Microcontroller Technical Information

| | | Document No. | ZBG-CD-08-0032 1/2 | | 1/2 |
| QB-78K0LX3 | | Date issued | August 4, 2008 | | |
| In-Circuit Emulator for | | Issued by | Development Tool Solution Group | | |

No. 9 Restriction on LCD output when using a specific EA

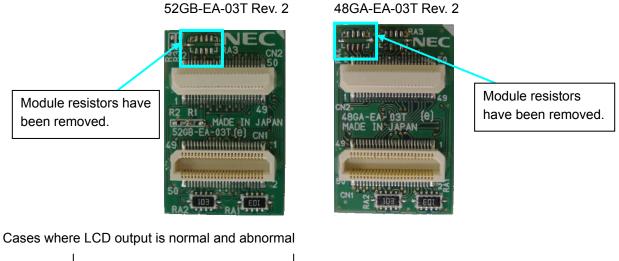
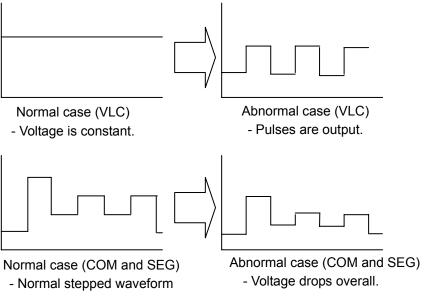
When the QB-52GB-EA-03T or QB-48GA-EA-03T is connected with the QB-78K0LX3, the voltage level of the output for LCD (VLC, COM or SEG) may drop.

This issue is corrected by upgrading the QB-52GB-EA-03T or QB-48GA-EA-03T from the 1st to the 2nd revision.

See the figures below for the EA versions.
